8.6 ACRES - US HWY 281
SOUTH OF BORGFELD

MASTER DEVELOPMENT PLAN

SHEET
EX-1

Re: 8.6 Acres US Hwy 281 South of Borgfeld Master Development Plan **MDP # 034-06**

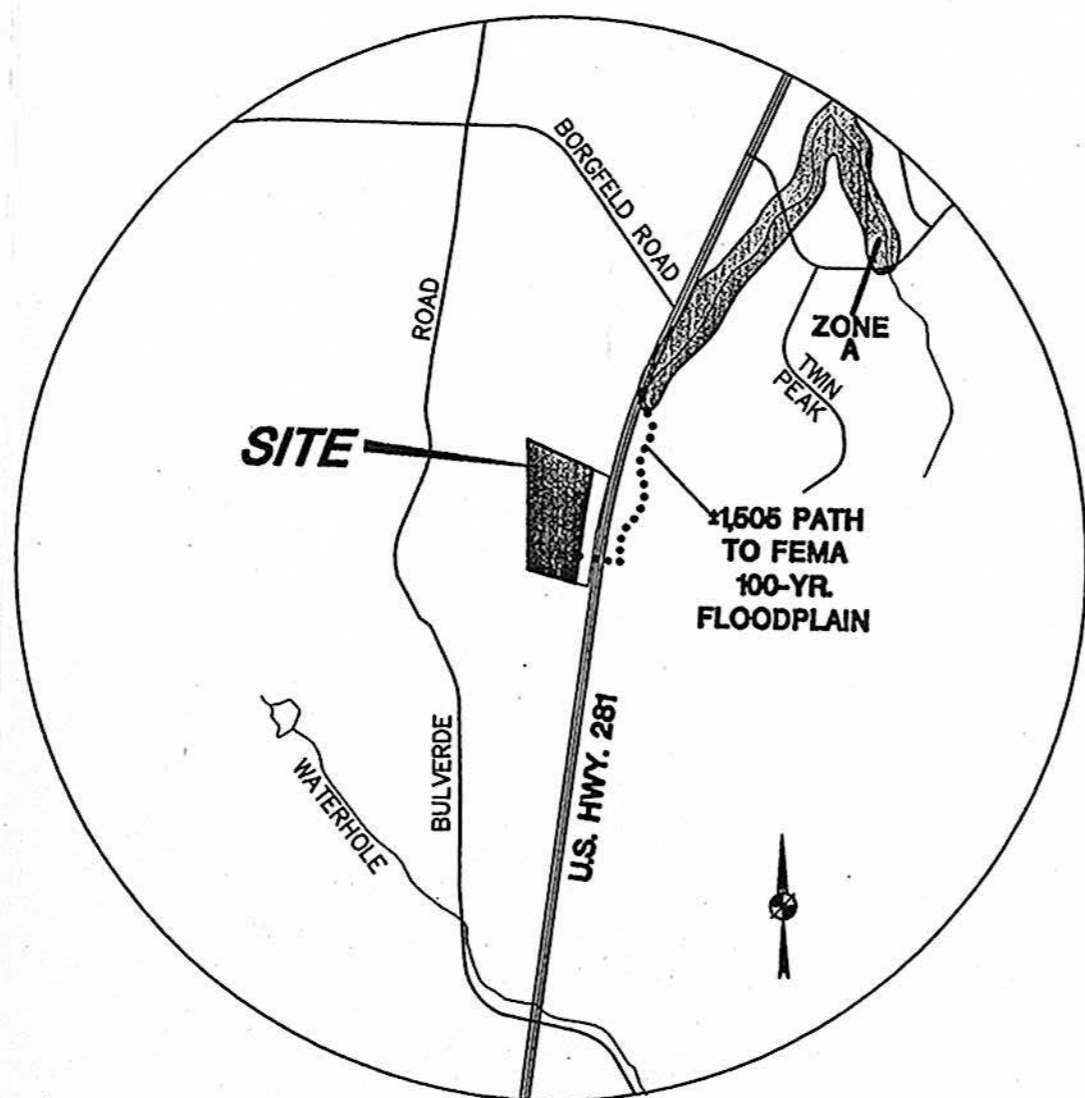
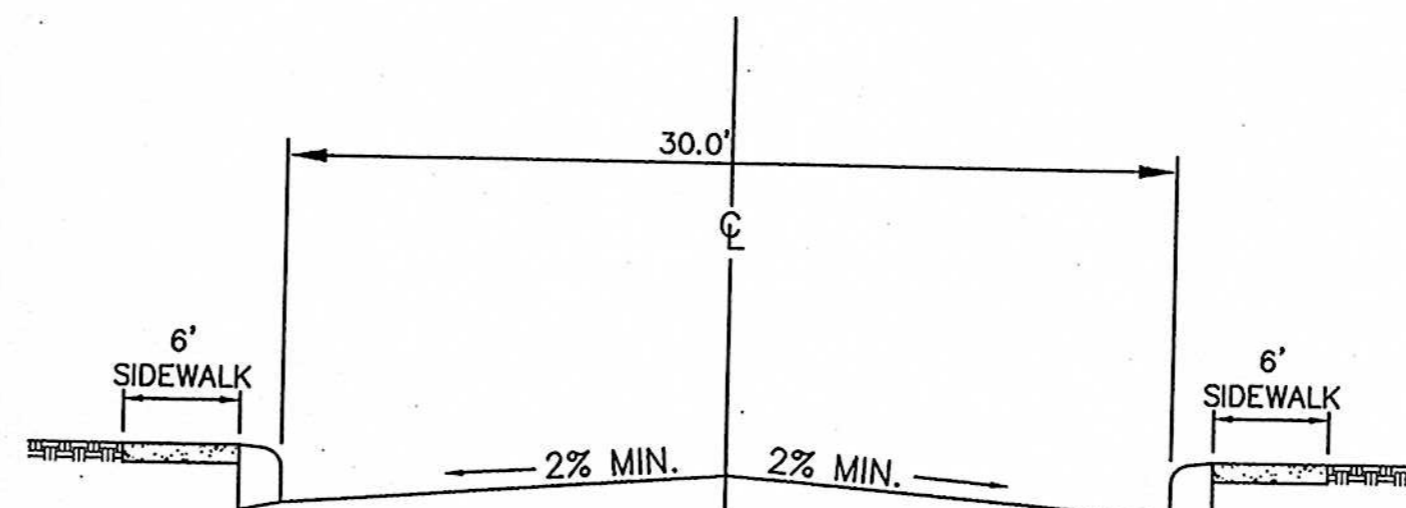
In consideration of public safety and convenience, excessive grades by reason of topography should be avoided in street layouts and arrangements. Any access and R.O.W. issues along state facilities will need to be resolved with the **Texas Department of Transportation (TXDOT)**. For information about these requirements you can contact TXDOT at 615-5814.

- Driveway throat lengths shall comply with UDC 35-506, Table 506-7.
- All commercial driveways for this project shall comply with UDC 35-506, (r) Access and Driveways.
- All access driveways shall provide clear sight distance along US Hwy 281 to provide adequate obstruction free viewing distances for approaching traffic. All signage, landscaping, and improvements shall be selected and located so as to not block these clear sight distance areas.
- The developer shall be responsible for providing acceleration and deceleration lanes with storage lengths and bay taper in all the driveway access points approved by TX DOT as it relates to the submitted TIA traffic counts, (Uniform Development Code (UDC) 35-502(a)(7), subsection C.

- It is understood that this MDP is a conceptual plan and all regulations will be addressed at time of platting. Bexar County reserves the right to address driveways, street design, sight distance, ADA requirements, drainage and floodplain issues at time of platting.

- 100 year Flood Plain shown and buffering (if applicable).
- Significant recharge features and buffering (if applicable).
- Category letter for all site specific plats (if Category 2 or 3, and Aquifer Protection Plan is required) (if applicable).

The Texas Department of Transportation has proposed construction plans for a grade separation at the intersection of US 281 and Borgfeld. This proposed project will construct a portion of the ultimate continuous frontage road, which will terminate in the vicinity of this property. As part of the right of way acquisition /negotiations, TxDOT will construct two temporary access points as depicted in the attached TIA exhibit prepared by Bury & Partners. In the future when US 281 is expanded to a full expressway section and the frontage roads are made continuous, TxDOT will permit a permanent access point to this property as depicted on the MDP and the attached TIA exhibit. Upon construction of the permanent access point, TxDOT will require the two temporary access points to be removed. As per TxDOT's "Access Management Manual", the permanent access point will require a right turn deceleration lane.
